Request to Change a PDA Development Application Pursuant to Section 99 of the *Economic Development Act 2012*

Parklands Drive and 71 Flagstonian Drive, Flagstone QLD 4280 (Lot 50050 on SP332140 and Part Lot 907 on SP332140)

Town Centre Stage 1 – Reconfiguring a Lot for Subdivision

EDQ Approval Ref: DEV2022/1313

Figure 2: Proposed Plan of Subdivision

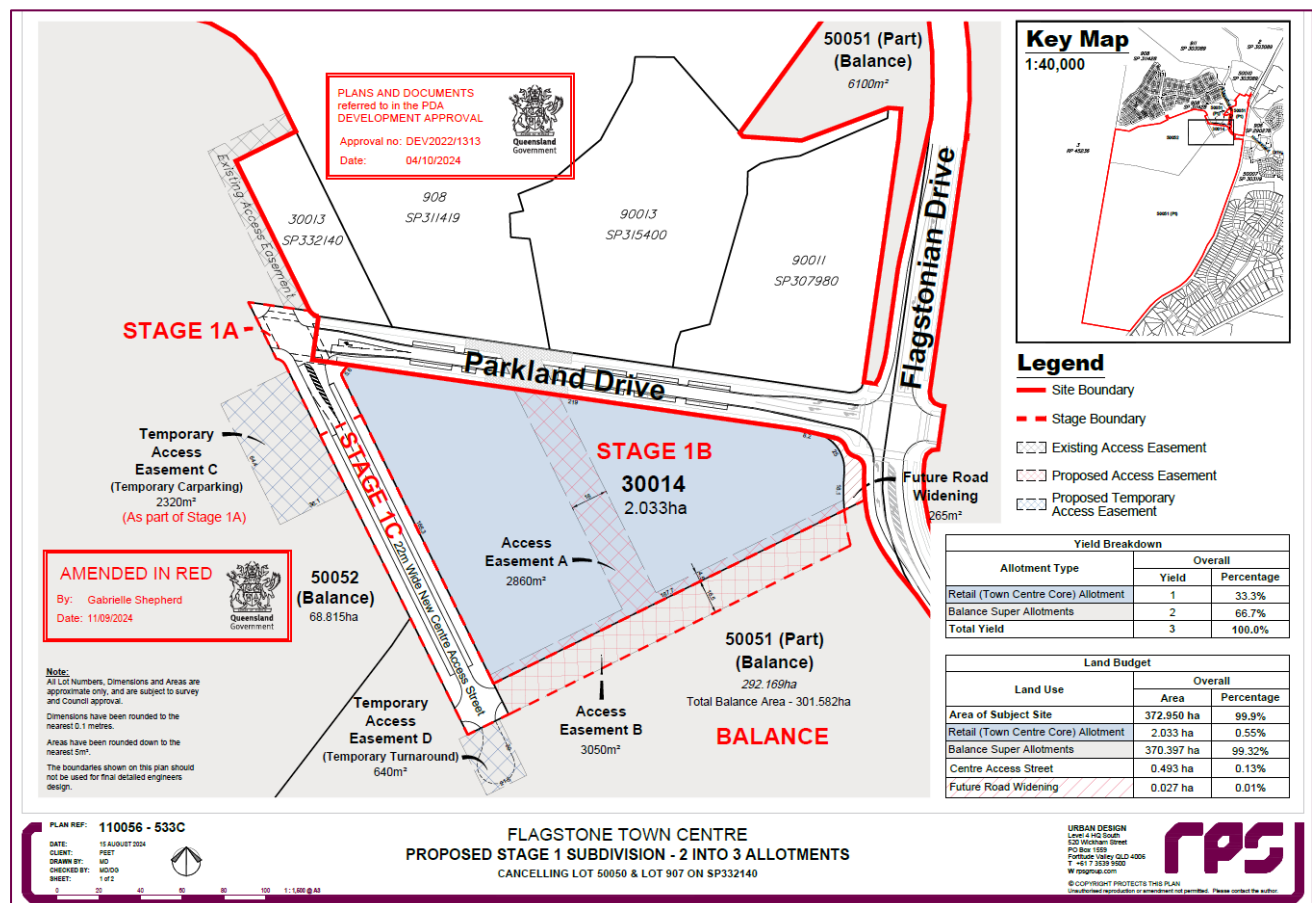
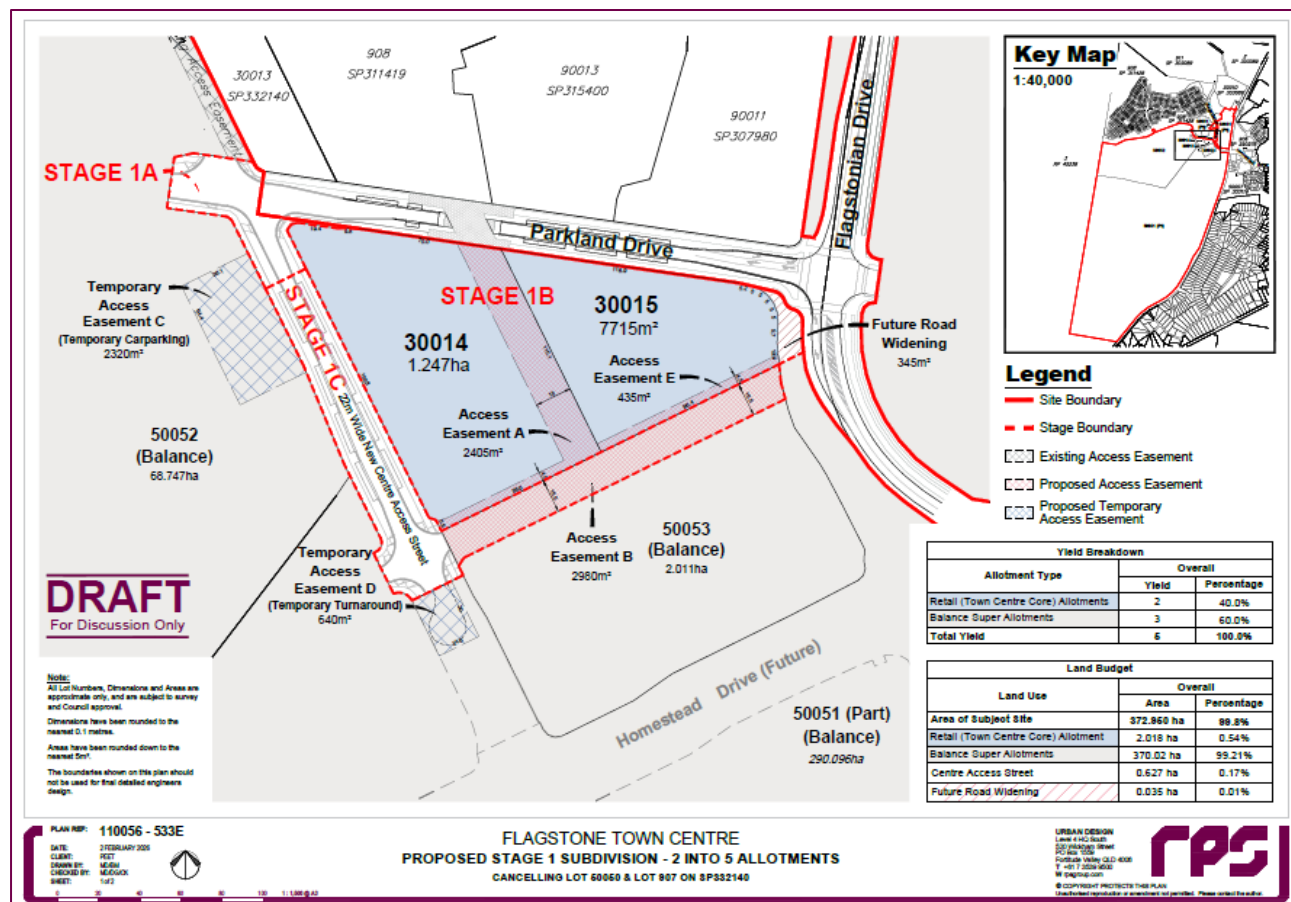
- Proposed 'split' of approved Town Centre Lot 30014 into two lots to accommodate the Leagues Club and private north-south road (Lot 30014) and future "Eat Street" commercial/retail uses (Lot 30015) separately.

- Proposed extra balance lot (Lot 50053) between Town Centre Stage 1 and Homestead Drive (currently under construction) to separate the balance lot area north of Homestead Drive which includes access easements for Stage 1 from the main balance lot for CA4 and CA5. .

- Amended extent of Stage 1A to accurately capture the western stub extent of the ultimate intersection design of Parkland Drive/City Centre Access Street.

- Updated linework for public roads and intersections having progressed detailed design phase.
- Increase in Future Road Widening area associated with Homestead Drive from 265m² to 345m².

We propose to alter Stage 1B to incorporate two lots instead of one, with separate titles for the eastern and western portions as proposed Lot 30014 (west) and Lot 30015 (east). The amendments are proposed to allow planning and design and approval activities to progress independently for Eat Street and the Leagues Club sites t, providing flexibility for Peet to advance commercial/contractual arrangements . Notwithstanding this, both lots are still delivered in a coordinated manner within Stage 1B.

- Access Easement A: 18m wide north-south road including 4.5m northern verge of Little High Street for Lot 30014 (**decrease** from 2,860m² to 2,405m² area).

- Access Easement B: 16.5m wide Little High Street (**increase** from 2,980m² to 3,050m² area). The change in area of Access Easement B captures the reduced frontage length of Little High Street. The easement tapers slightly at the southwest corner to accommodate the initiative pedestrian footpath alignment.
- Access Easement C: Temporary Carparking (2,320m² area).
- Access Easement D: Temporary Turnaround (640m² area).
- **New** Access Easement E: 4.5m northern verge of Little High Street for Lot 30015 (435m² area).
- **Revised** extent of City Centre Access Street: 22m wide typology.

Figure 4: Approved and Proposed Road Widening

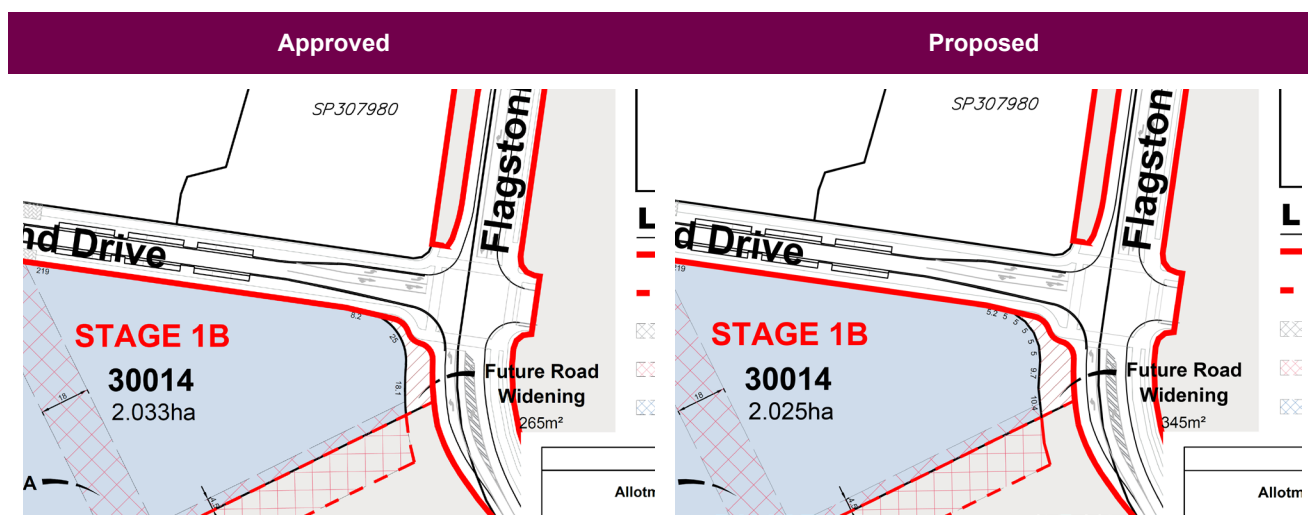
The engineering plans for Homestead Drive (currently under construction) provided by Colliers demonstrate an interim and ultimate earthworks extent which is slightly larger than the current future road widening area approved in this Town Centre Stage 1 ROL.

As such, we seek to amend the road widening area to accurately capture the ultimate extent of road. The future road widening area is proposed to increase from 265m² to 345m². This change will result in a reduction developable land in Stage 1B. Refer to **Figure 4**.

These works earmark land required for the future ultimate Flagstonian Drive road reserve within balance Lot 50051. This ensures the eastern extent of lot 30015 is accurately defined ahead of the future road dedication, providing certainty regarding the developable and saleable land area within Stage 1B.
